**From:** Darryl Howells [REDACTED]  
**Sent:** 15 January 2026 17:25  
**To:** Simon Davis <Simon.Davis@arun.gov.uk>  
**Subject:** RE: BE/143/25/OUT

## RE: BE/143/25/OUT - Land East of Heath Place, Bersted, West Sussex, PO22 9SL: Environment Agency Position

Figure 1: Modelled Defended Tidal Outlines (Source: EA Product 4 Dataset)

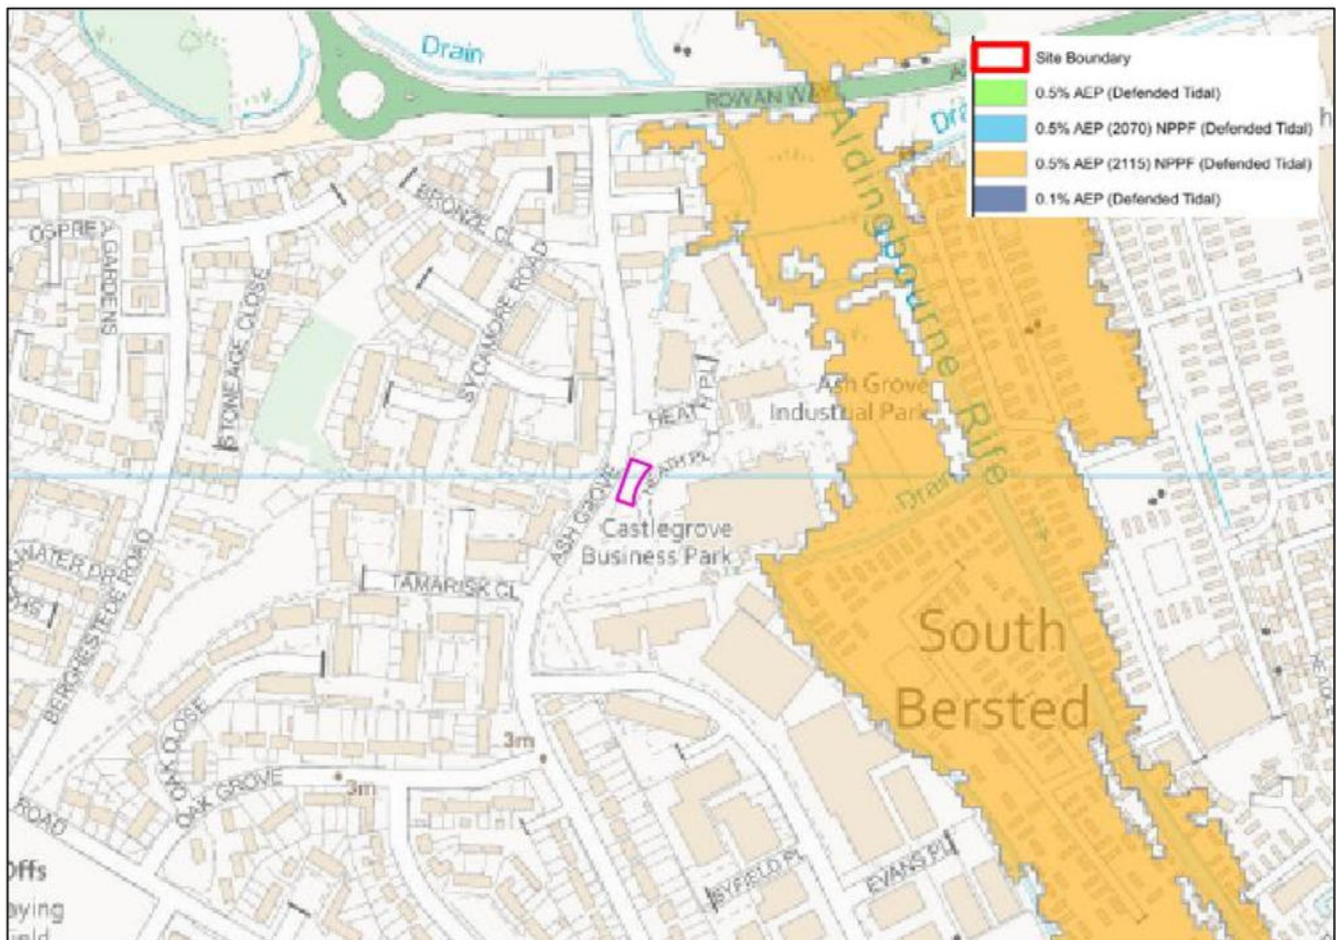
*o flood risk mitigation measures to address flood risk for the lifetime of the development included in the design are inadequate because they will not make the development resistant to the flood levels for the 0.5% AEP (2115) tidal design flood event. Consequently, the development proposes inadequate raised finished floor levels.*

We recommend floor levels are set at least 600 millimetres (mm) above the estimated flood level. The design flood level for areas at risk of tidal inundation, should be a 1 in 200 annual probability event plus an allowance for climate change.

If you cannot raise the floor levels in this way, you will also need to include extra flood resistance and resilience measures. These measures should protect the property to at least 600mm above the estimated flood level.

The site isn't affected by 1in200 (2115) flood extents, as shown in Figure 1 below. The closest 1in200year+CC flood level is 1.07m AOD. The topographic levels of the site vary between 1.50m AOD and 2.60m AOD. The proposals incorporate undercroft parking with the proposed residential first floor level built into the embankment to be set at 3.95m AOD. Which is 2.88m above the 1in200 (2115) tidal flood level.

Given that the site is unaffected by the 1in200 (2115) scenario and that all residential use is to be set 2.88m above the closest design flood level, there is no requirement to incorporate additional raising of finished floor levels or any additional flood resilience measures other than those that have been outlined within the original FRA.
